EA Project No.: 16-1100

DATE OF ISSUANCE: February 14, 2017

Notice: This addendum is issued to all prospective bidders as an amendment to the Drawings and Project Manual for the Canopy Row. Bidders shall acknowledge this addendum on the Bid Form. All information contained herein shall be fully incorporated into the Contract Documents as though originally included therein.

M300

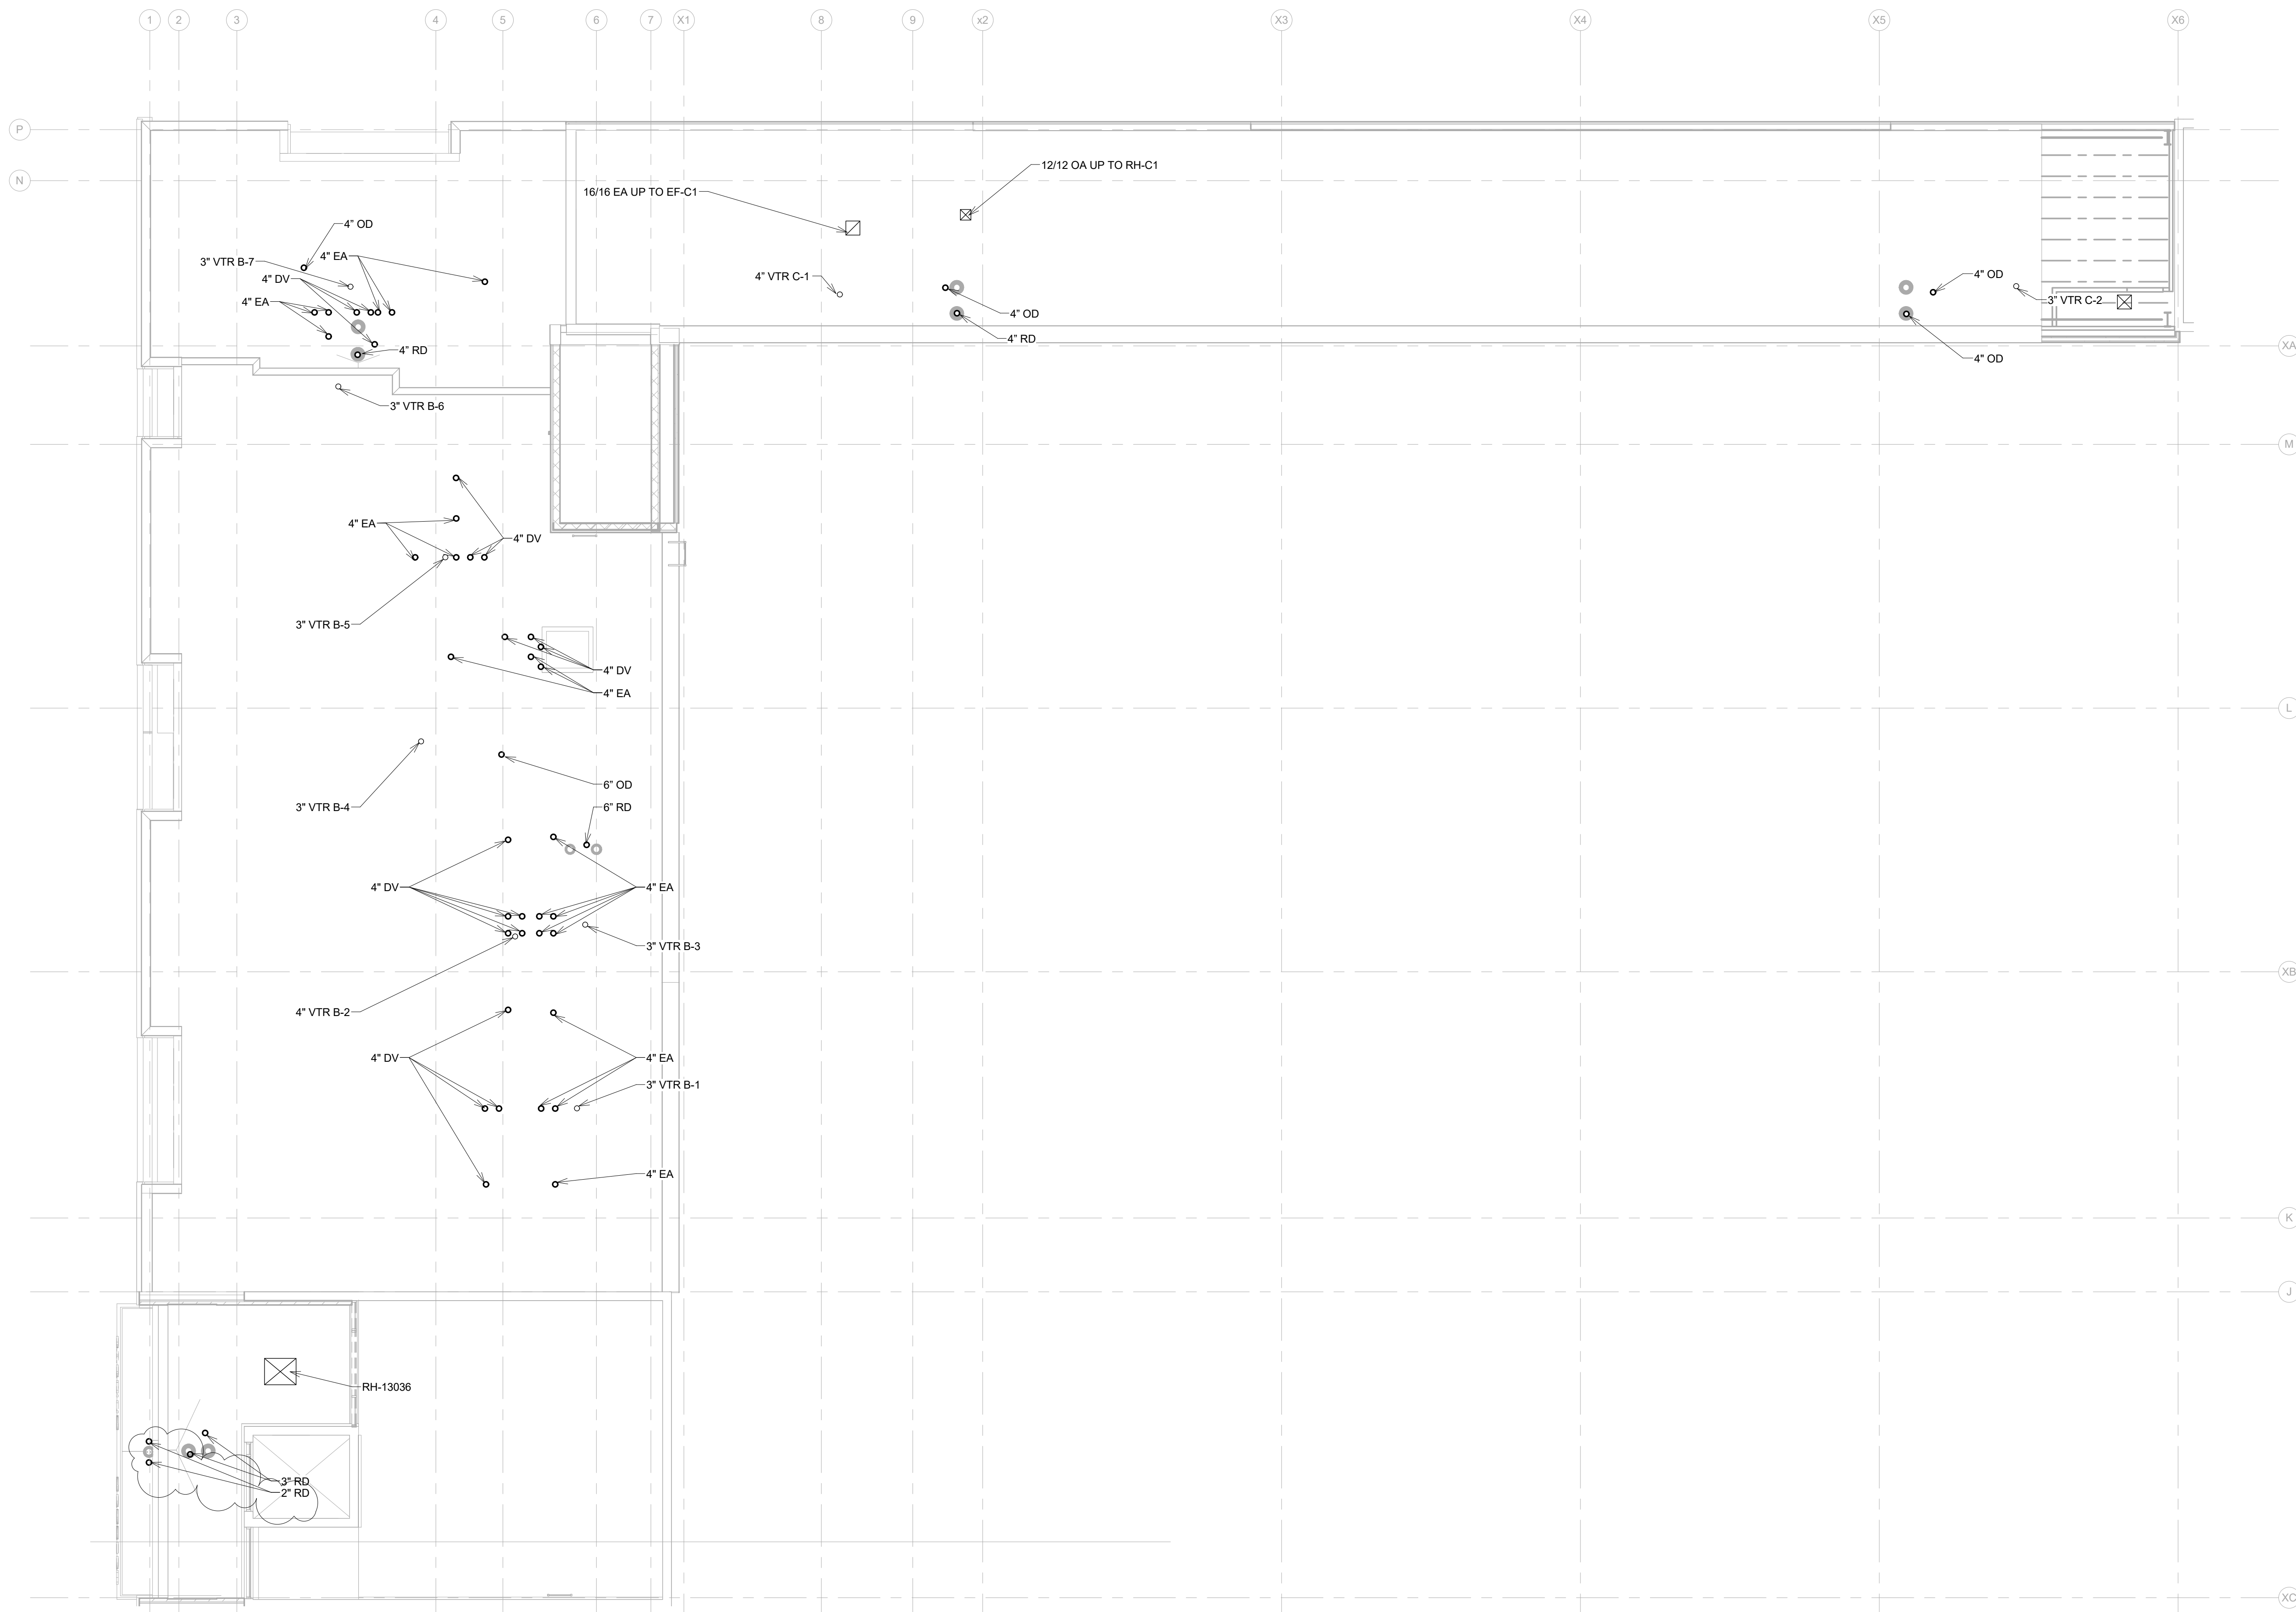
Reference Revised Sheet M300

Add second HWP-2 to be installed below HWP-1 and change piping connection of HE-2 from upstream of HE-1 to downstream of HE-1.

Add section showing the pipe routing of the 2" roof drains in the canopy over Vestibule 101 entrance to the under floor 3" storm.

ENLARGED VIEWS
ADDENDUM 2: CHANGE NOTE TO "HWP-1 ABOVE HWP-2 BELOW" WAS "HWP-1" IN
DETAIL 2 (LOWER LEVEL PLUMBING - CALLOUT 1) REVISE HE-2 PIPING FROM UPSTREAM
OF HE-1 TO DOWNSTREAM OF HE-1 IN DETAIL 2. ADD DETAIL 3 FOR SECTION OF 2" RD
GOING DOWN WALL IN VESTIBULE B101
